Planning Application Ref: AW/318/21/T

Location: 3 Seacourt Close Aldwick PO21 4RD

Description of works: 1 No. Oak tree - Crown thin by 25% and Crown Lift to 2m

Figure 2 Positions of final cuts

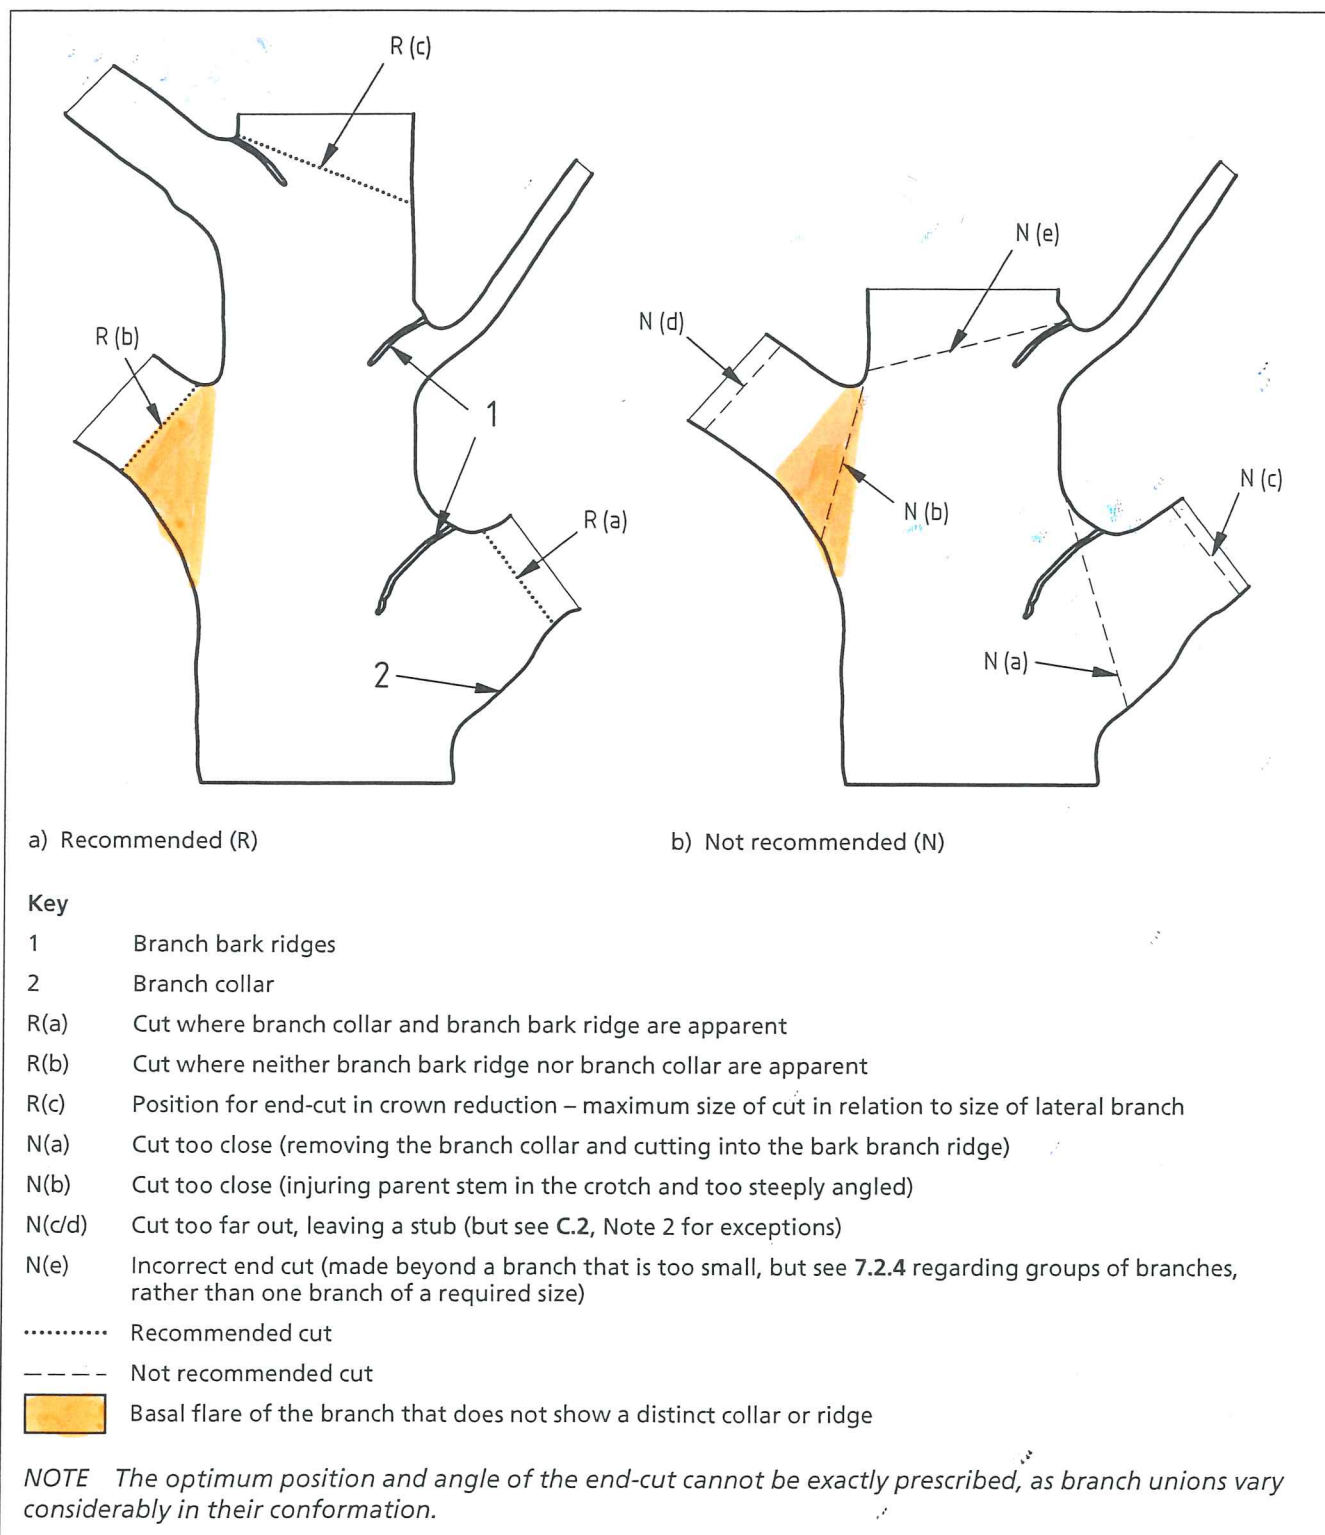
Part a) Where whole branches are to be removed and final cuts made close to the trunk or branch union they are to be made as shown in Figure 2 of BS3998:2010
